## **I 1.5.6 ACOUSTIC REPORT**

**Redcliff Quarter, PBSA Block - Acoustic Design Advice**

**Reference: 10014/AW**

Acoustic Consultants Limited have been appointed provide noise and acoustic advice for the purpose built student accommodation development at Redcliff Quarter, Bristol.

Figure 12: SVP Detail

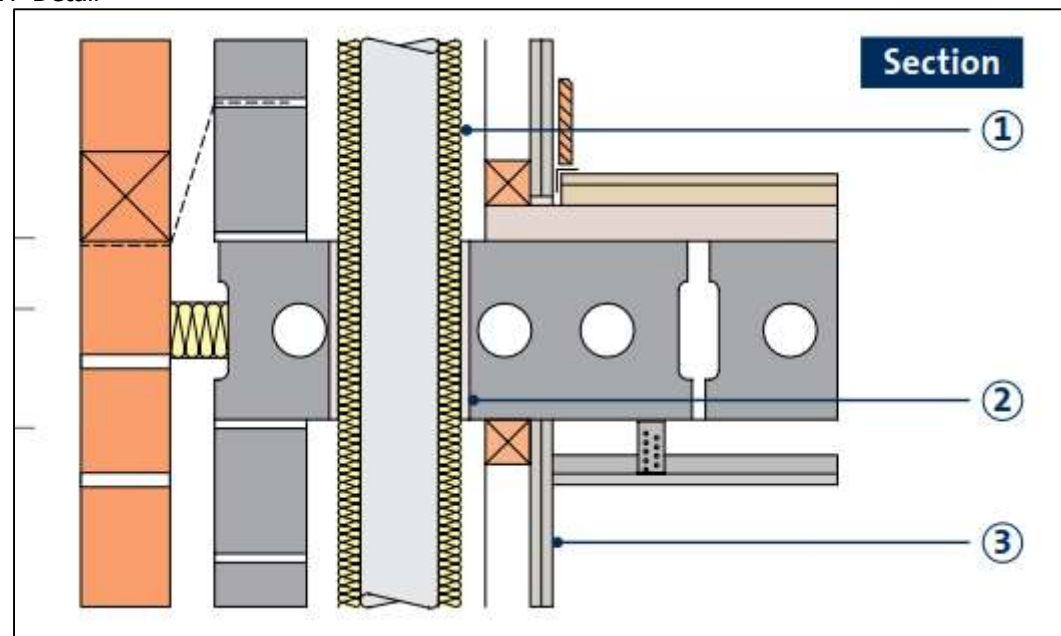
Please note the current SVP enclosure does not include mineral wool. This should be included. A typical detail is provided below:

Figure 19: Roof plant plan

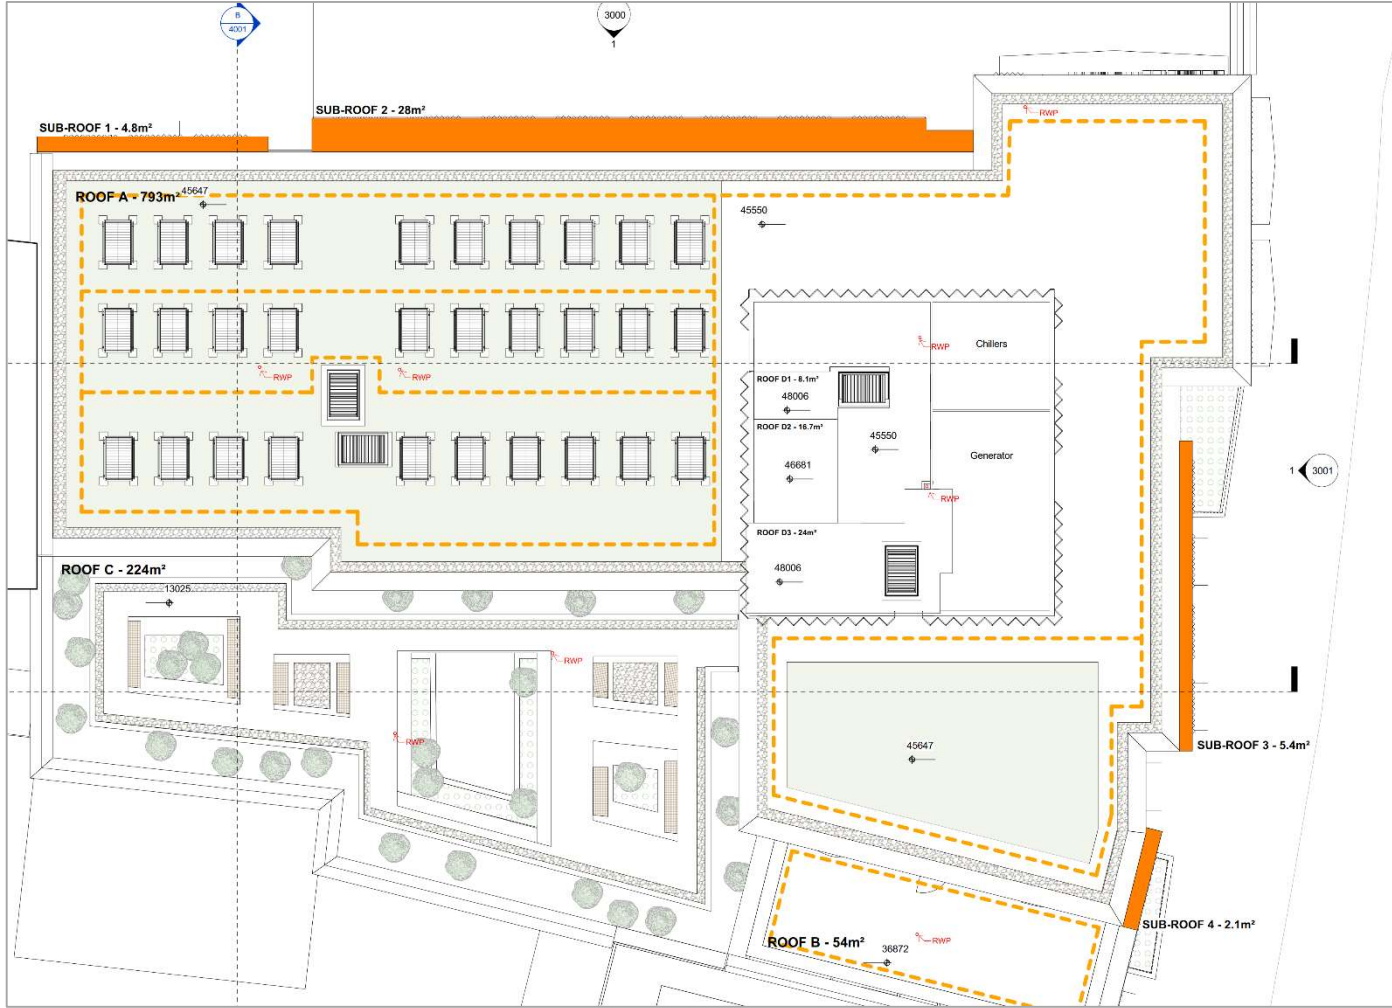
and night. As such, it will be necessary to change the plant selection to a unit with lower sound levels, or install additional plant noise control measures.

It will be necessary to reduce the sound level of the chiller by at least 7dB(A), or change the selection to a unit with a maximum manufacturer's sound power level of 80dB(A). The required sound attenuation could be provided by a specialist acoustic enclosure.

Figure 4: Proposed acoustic enclosure

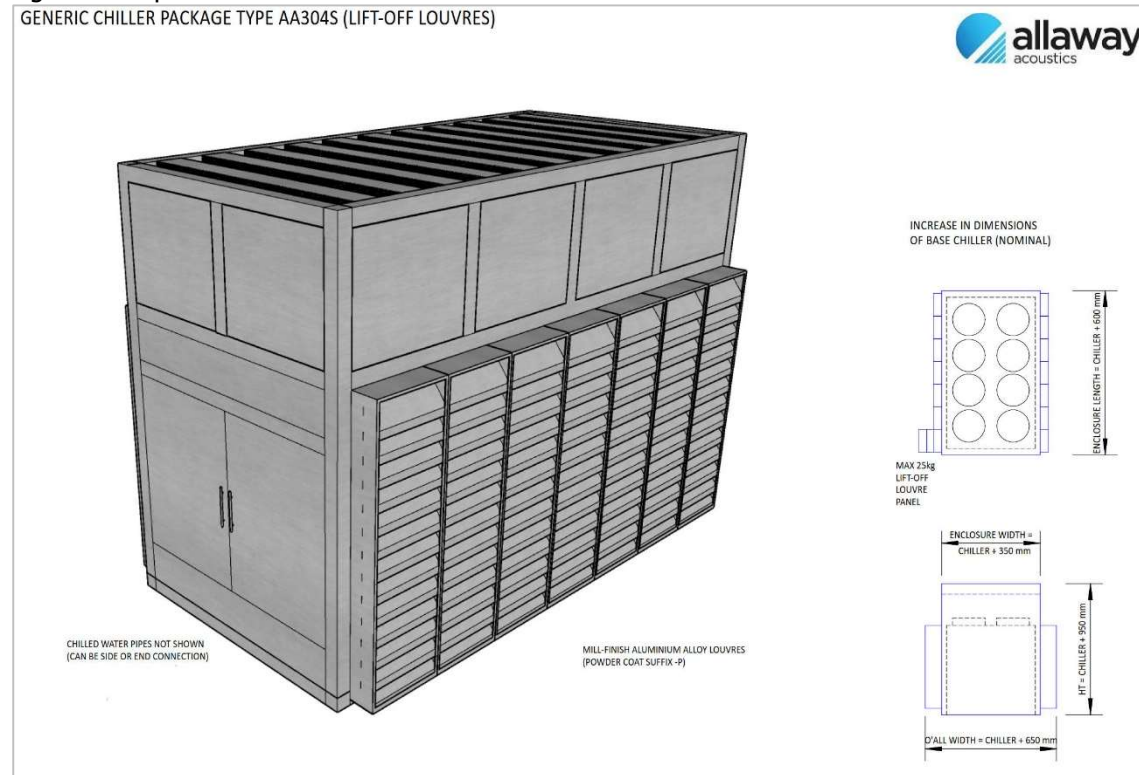
It is proposed to install an acoustic enclosure around the chillers. The proposed enclosure is as follows:

We have been advised that the above enclosure provides 8dBA of sound reduction, inside to out. The supplier/manufacturer should confirm that this sound reduction will be achieved.
